5th EGM (15.07.2008)

Panther housing

Van Vihar National Park

PROPOSED PANTHER HOUSING AT VAN VIHAR BHOPAL

LAYOUT PLAN

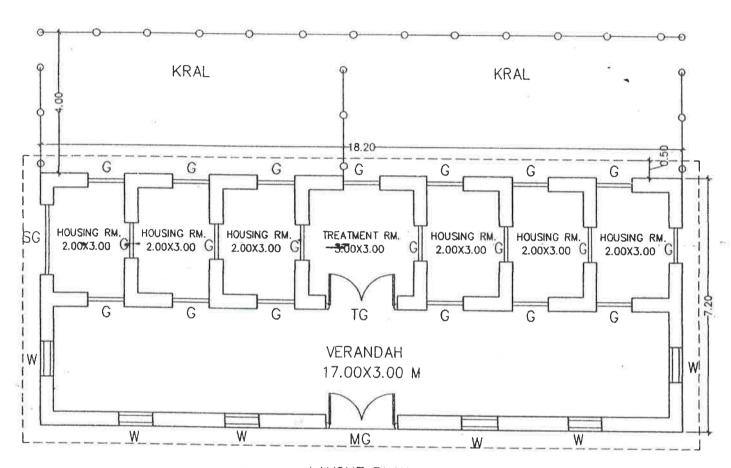
- 1. The proposed treatment room should have a attached squeezed cage.
- 2. Instead of providing kraal (as shown closed to night shelter) a paddock of 500 sq. mts area for housing a pair of leopard need to be provided.
- 3. A kraal shall be provided on both sides of the night shelter.
